Our Case Number: ABP-317742-23

Re: BusConnects Bray to City Centre Core Bus Corridor Scheme
Bray to Dublin City Centre.

BRAY TO CITY CENTRE CORE BUS CORRIDOR SCHEME

Strategic Infrastructure Development Application

Fig 3

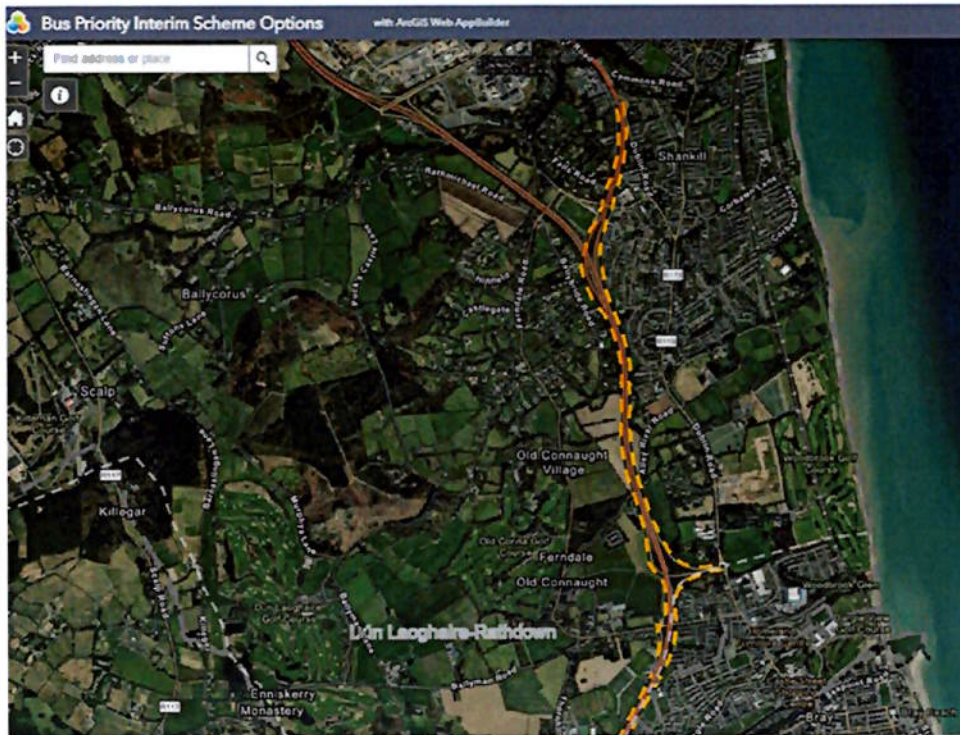
However, the link to Wicklow County Council's website [N11-M11-Bus Priority Interim Scheme](#) for the new proposed bus priority measures on the M11/N11 between Loughlinstown Roundabout and the Glen of the Downs demonstrates that bus priority measures on the M11/N11 corridor were in fact quite feasible. Drawings of the proposal are available on the website. A plan of the northern section, coinciding with Section 3 of the Bray to City Centre Core Bus Corridor is shown in Fig 3.

I am not advocating the removal or re-direction of bus services from Shankill; however, it appears that an Option that was summarily dismissed at Feasibility and Route Options Stage is now not just acceptable but is seeing the light of day and it would appear that the severe constraints identified at the time of the Feasibility and Options Report have been successfully overcome so as to allow priority bus measures to be accommodated within the motorway reservation in the section of the M11 between Loughlinstown Roundabout and Wilford Junction (Junction 5).

Fig 5

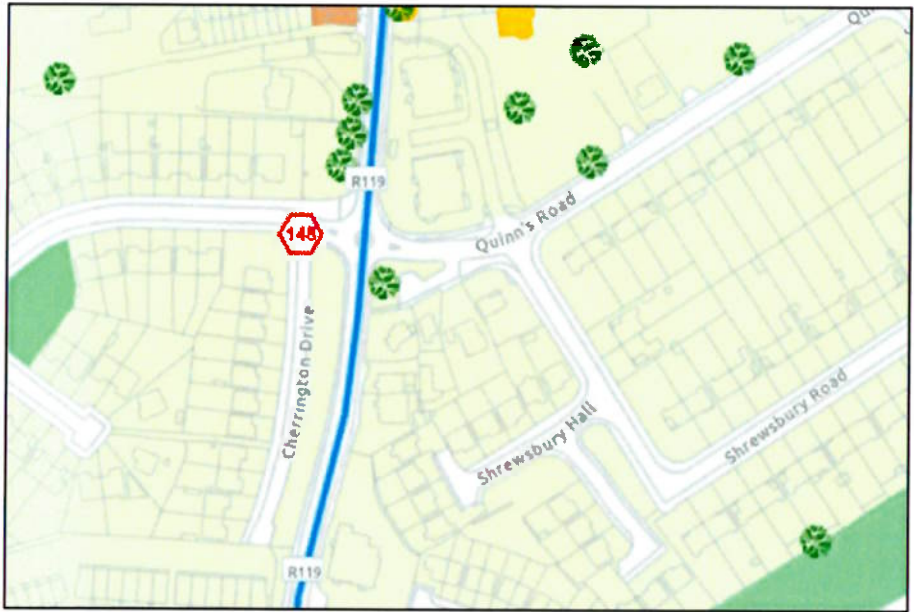
The proposed removal of the roundabouts at St. Anne's Church and at Quinns Road/Cherrington Road directly contravenes SLO 148 which is *"To protect and safeguard the roundabouts on the approaches into Shankill village at St. Anne's Church and at the junction of Dublin Road (R119) and Quinn's Road."*, see Figs 4 & 5.

Fig 8

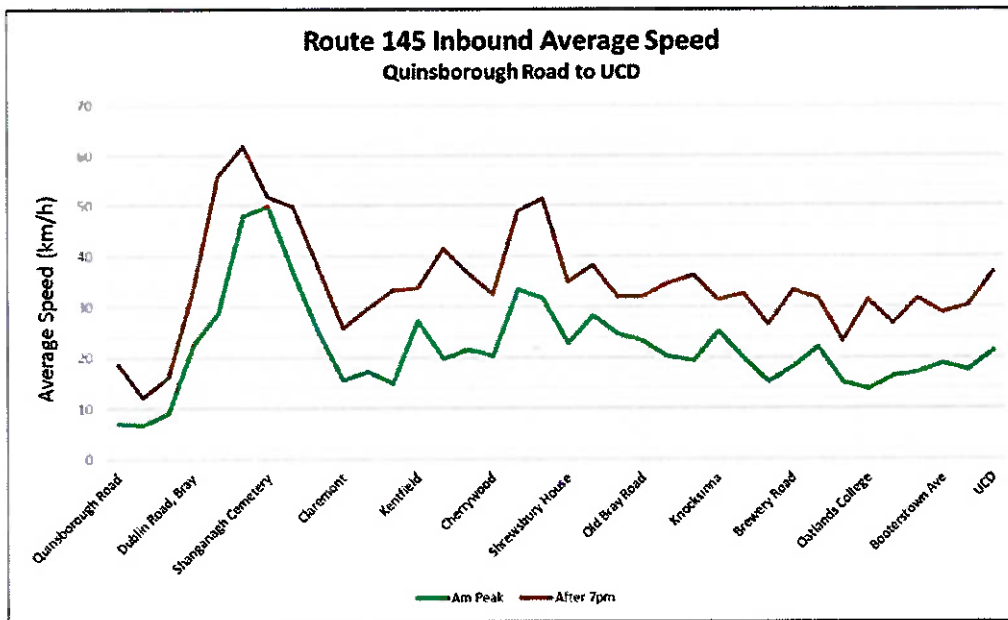
The Bray to UCD CBC Feasibility and Options Report presents in Section 8.4.3 the inbound and outbound journey time profile between Bray and UCD for the 145 route. These are shown in Figs 8 and 9.

Of particular note is the journey time profile between Shankill Village and Wilford. Inbound, (Fig 8), journey peak time bus speeds are 50km/h in the am peak, but reducing at Claremont at the southern edge of Shankill Village. Off-peak after 7pm, the average speed is marginally over 60 km/h, again dropping on the immediate approach to Shankill village. The speed limit on this section of road is 50km/h. So at peak times, average bus speed matches the speed limit.

Fig 9

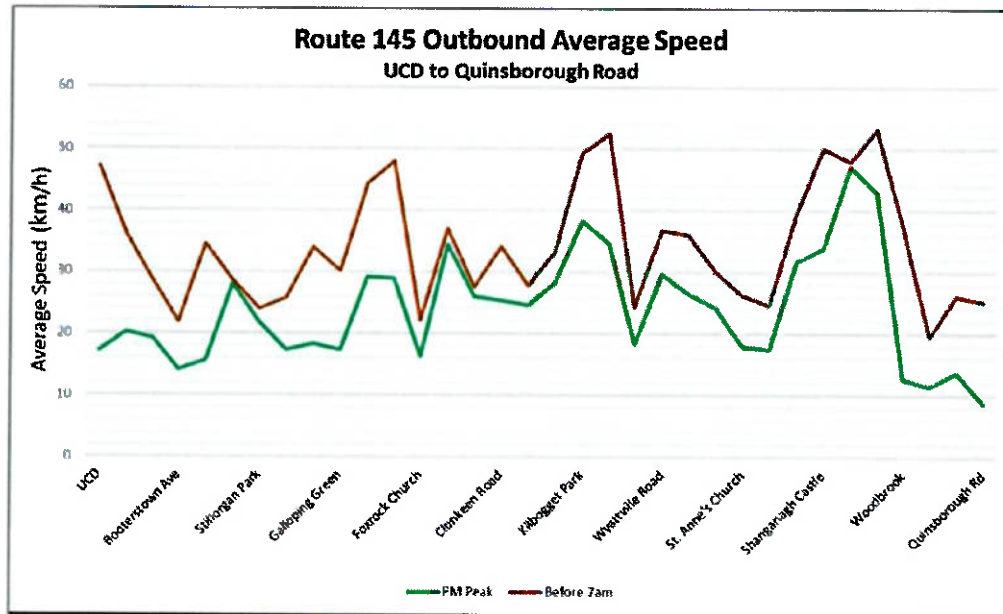
Outbound presents a similar profile – but in reverse, (Fig 9). Southbound bus speeds, both peak and off peak, increase at Shankill Village, rising to approximately 46km/h between the village and Wilford in the pm peak and to 54 km/h before 7am.

Fig 10

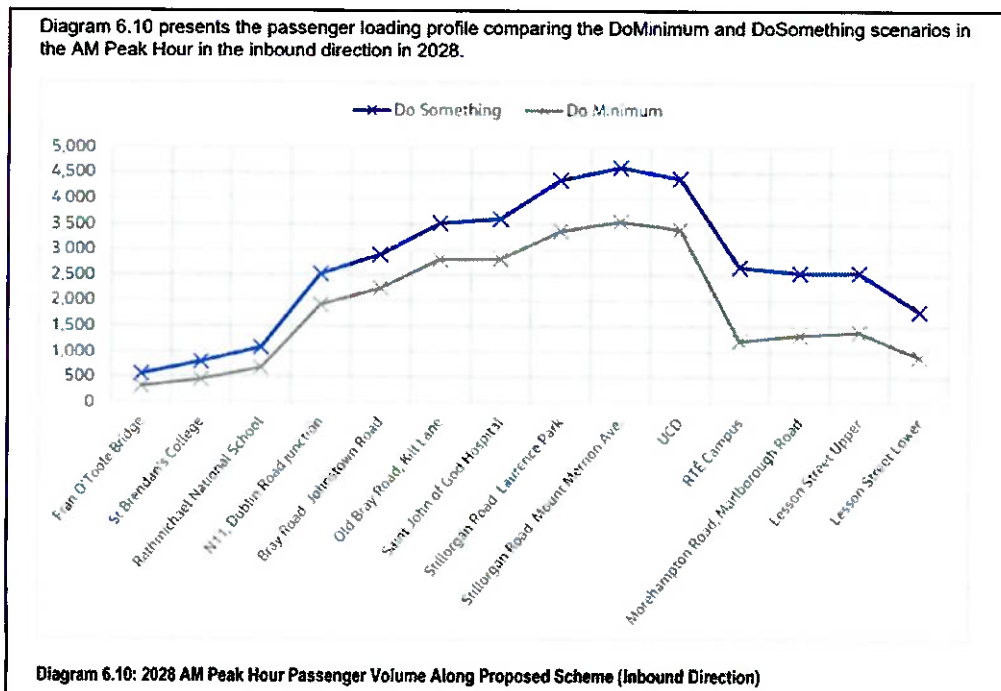
The following is clear as regards the graphs presented in this Section of the EIAR, see Figs 10, 11 & 12.

- a) It is clear from Fig 10 that Section 3 and Section 4 of the scheme coinciding with Shankill and environs has the lowest Peak Hour passenger volumes of any section of the scheme and the lowest absolute increase in passenger numbers between the Do Minimum and Do Something Scenarios,
- b) Fig 11 demonstrates that the time savings as modelled would appear to be very modest along the 3.3km section from Wilford to Loughlinstown Roundabouts – Chainages approximately 1,100 to 4,400 – 2028 Scenario – Inbound AM Peak'
- c) Fig 12 shows that for the outbound PM Scenario, the Do Minimum and Do Something lines are parallel along the sections of route coinciding with Loughlinstown to Wilford Roundabouts – indicating that little or no journey time benefit is being derived along this section arising from the Do Something intervention.
